The Banks – Phase 3C
Public Infrastructure Development
Bid Package #2 – Lot 28 Park & Garage
January 13, 2022
THP #98090.40

ADDENDUM #2

DRAWING TITLE
GRADING PLAN

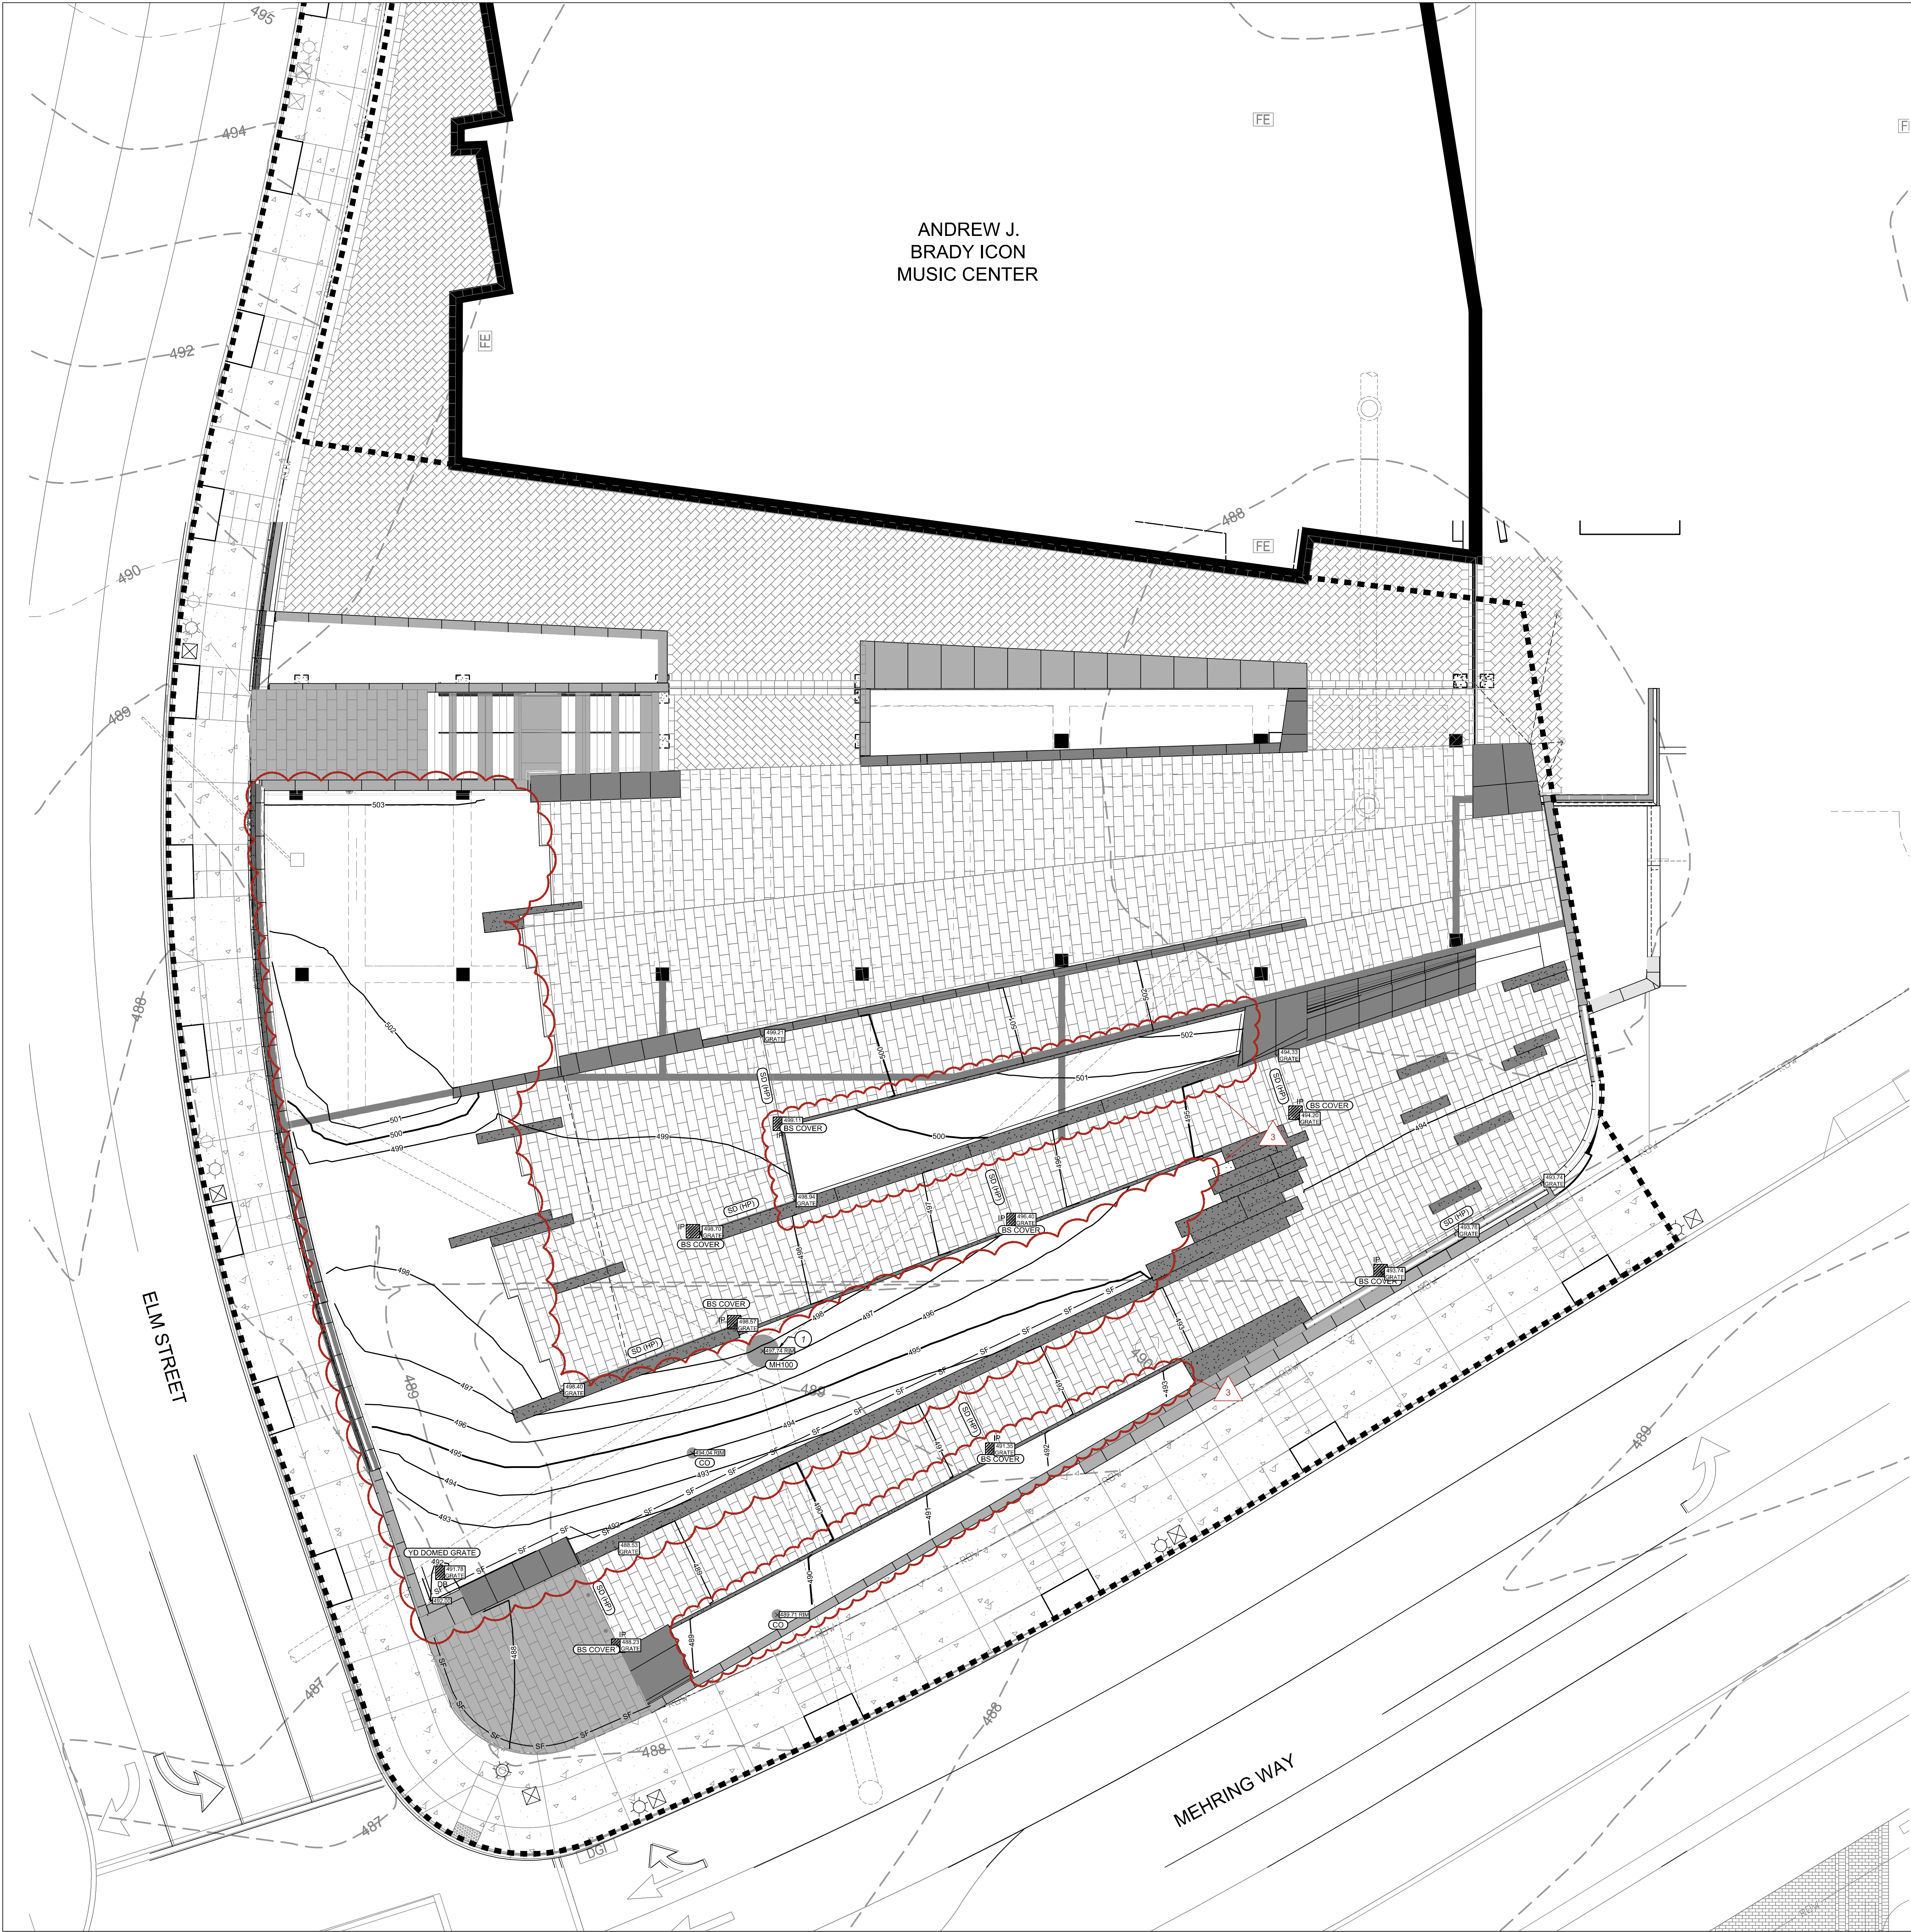
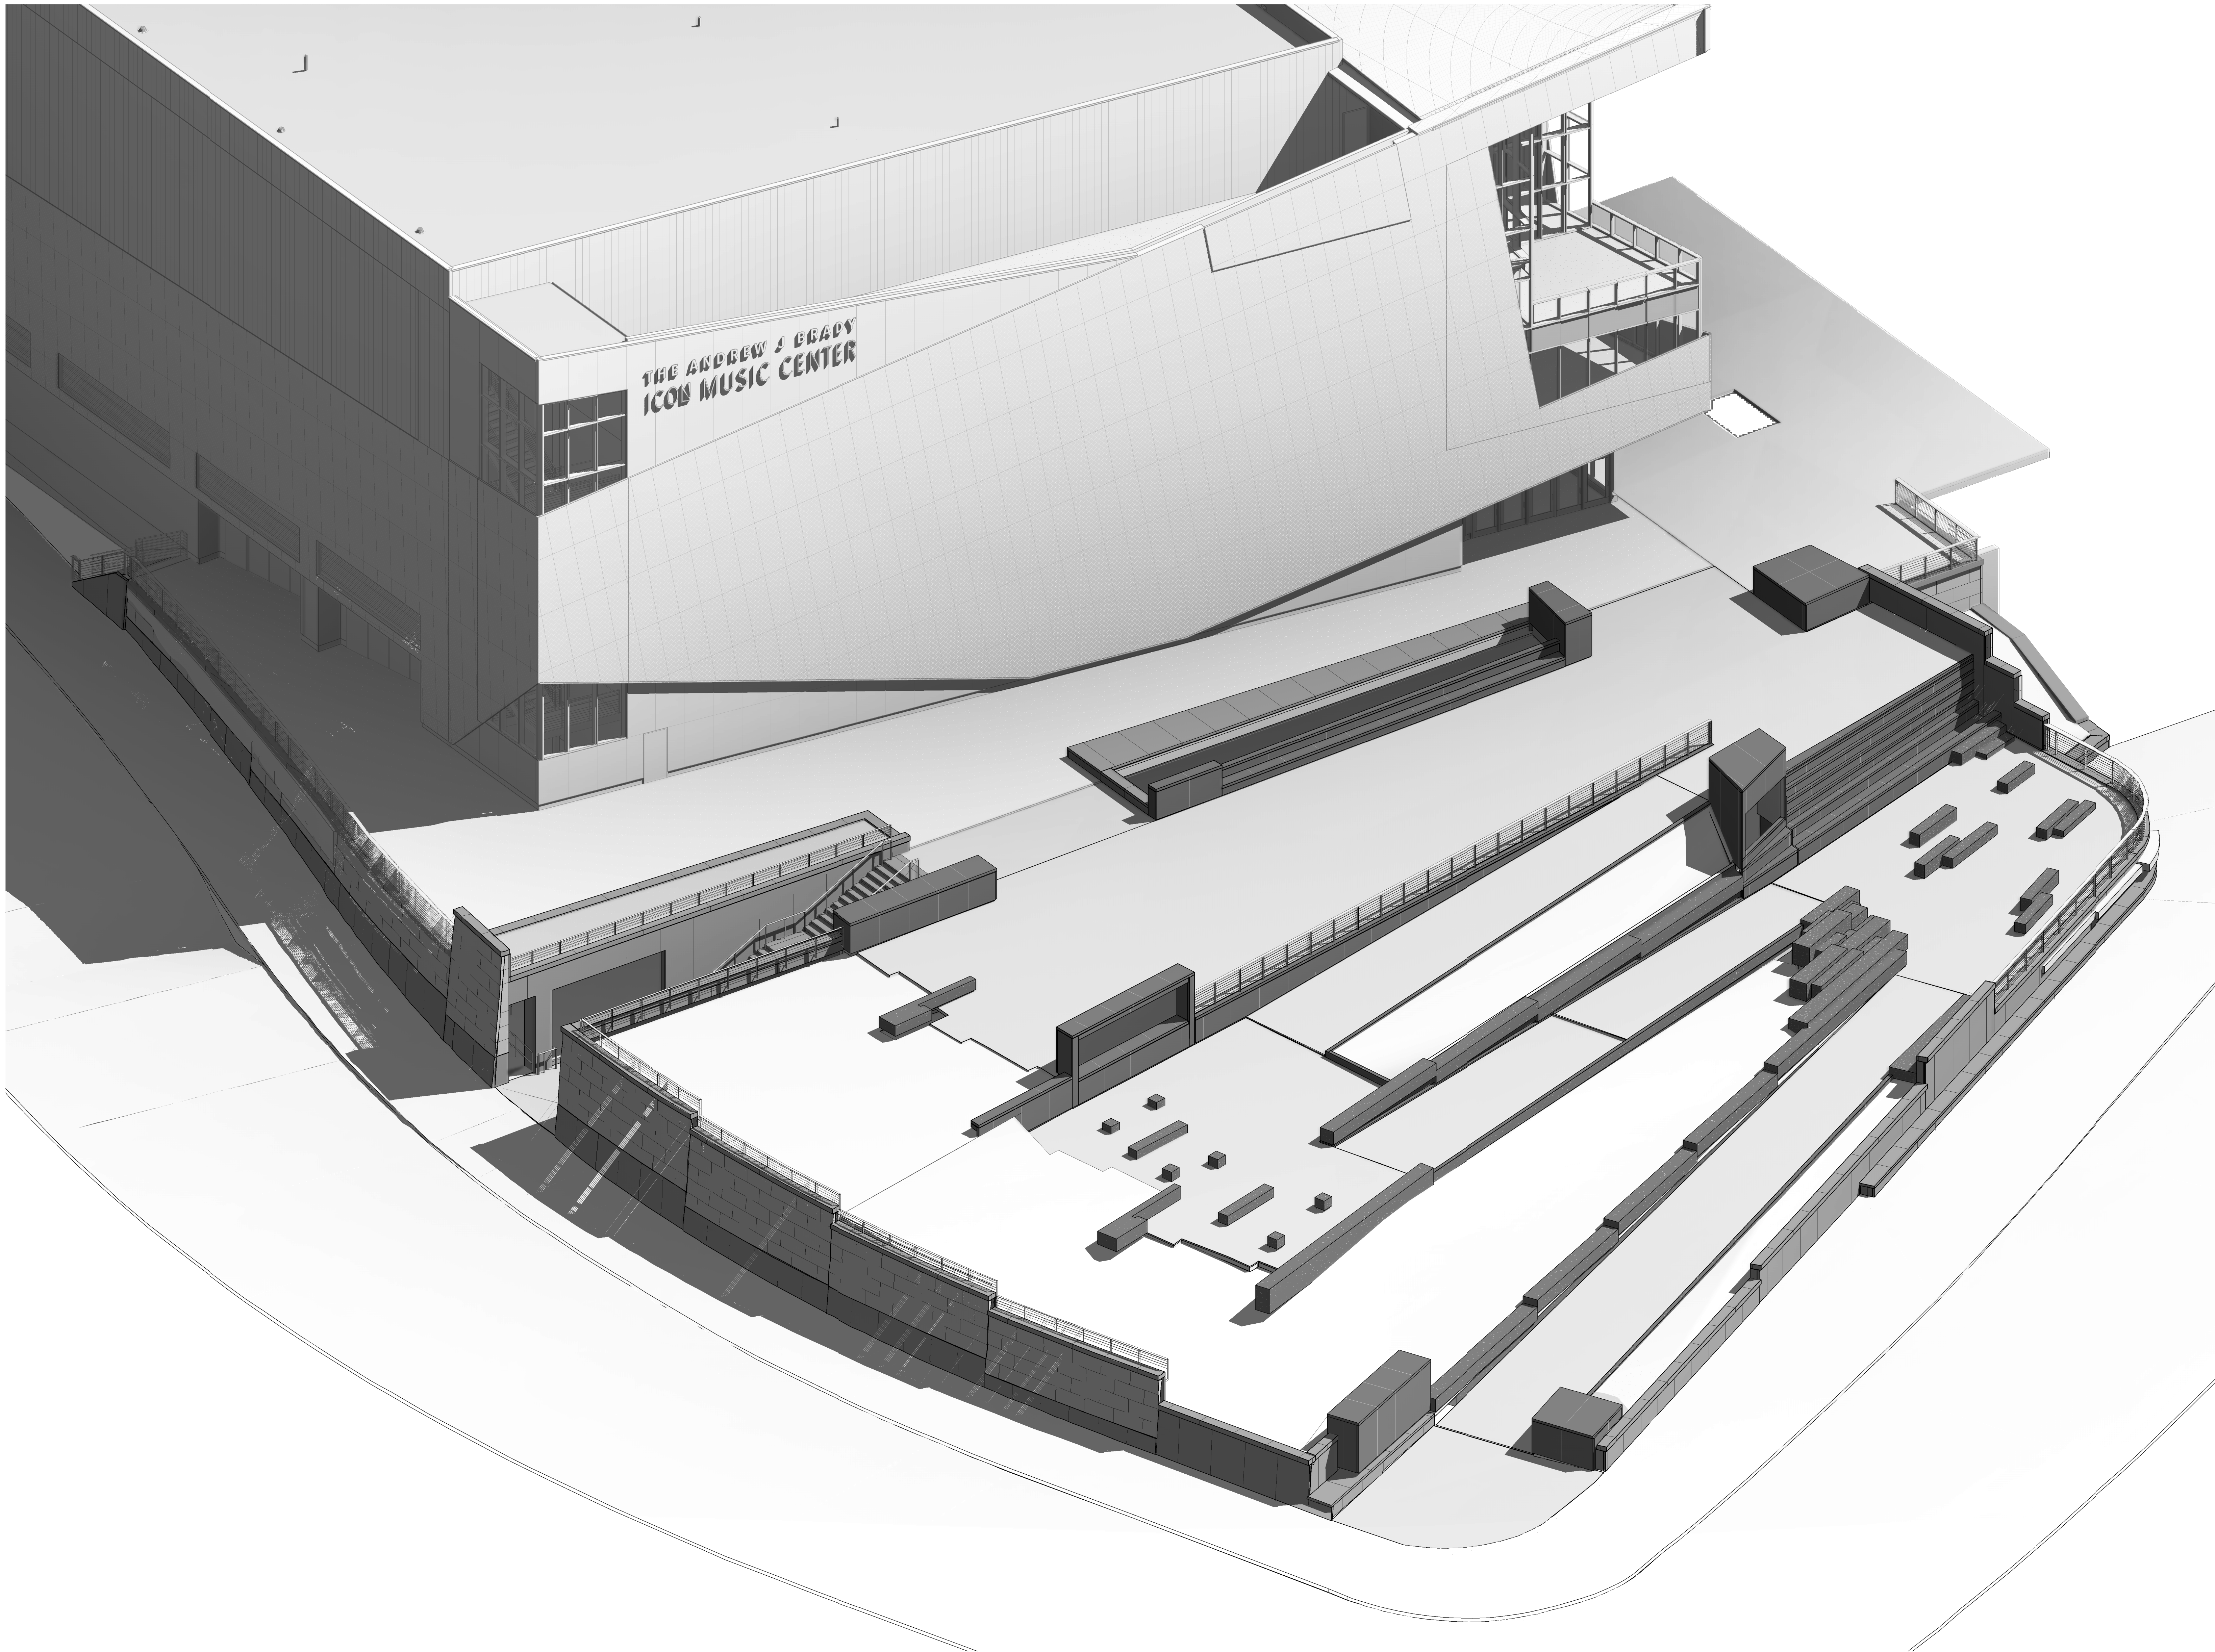
1. **Drawing C102.1:** (Sheet Reissued)
 - Revised Rim elevation M100.
 - Revised Mehring Way clean out elevation.
 - Revised Elm Street clean out elevation.
2. **Drawing C103:** (Sheet Reissued)
 - Revised grading in landscape areas.
 - Wall extended 7' west on radial line 5, revised grading at wall/landscaping.
3. **Drawing A002:** (New Sheet Issued)
 - Revised drawing per clouded areas.
4. **Drawing A101:** (Sheet Reissued)
 - Revised drawing per clouded areas.
5. **Drawing A102:** (Sheet Reissued)
 - Revised drawing per clouded areas.
6. **Drawing A202:** (Sheet Reissued)
 - Granite finish clarifications and updates.
7. **Drawing A220:** (Sheet Reissued)
 - Bollard detail removed/replaced.
 - Shading updated.
8. **Drawing A230:** (Sheet Reissued)
 - Details revised, see drawing per clouded areas.
